PG&E Letter DCL-14-110

Diablo Canyon Units 1 and 2
Docket No. 50-275, OL-DPR-80
Docket No. 50-323, OL-DPR-82

One-Hundred-Twenty-Day Response to NRC Request for Additional Information –
National Fire Protection Association Standard 805

Figure 1: Turbine building temperature gauge layout

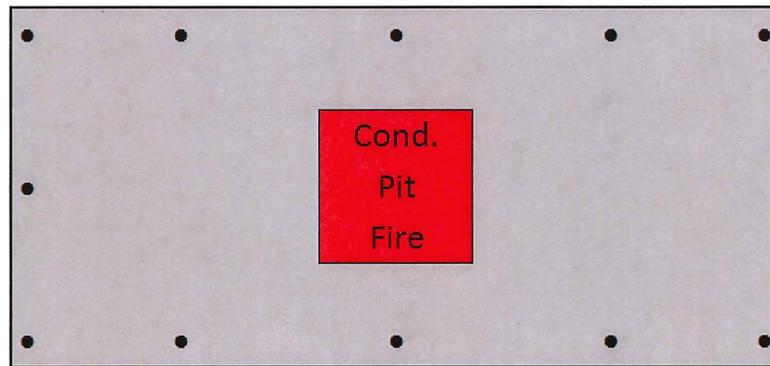
- h) Specifically regarding the CFAST analysis in Fire Zone 14-D, please describe the input parameters for the fire modeling and detailed results of this assessment.

Strings of temperature devices are strategically placed from floor to ceiling around the perimeter of the model to analyze the temperature at representative column and beam locations where structural steel is exposed. These devices, along with an FDS Z-plane slice file, measuring temperature near the ceiling, allow for a temperature profile of the walls and ceiling to be analyzed for potential structural steel damage. If any temperature device in a

floor to ceiling string for a given location reached the critical temperature of steel, it was assumed structural damage was possible for any members at that location. No devices were placed directly above the fire as localized damage (i.e., within the flame/plume) is assumed above the pit. If timing for purposes of calculating nonsuppression probabilities is performed, the structural steel beams and columns within the flame/plume region would need to be assumed failed in the early stages of the fire scenario. The temperature gauge layout is shown in the Figure 1 below.
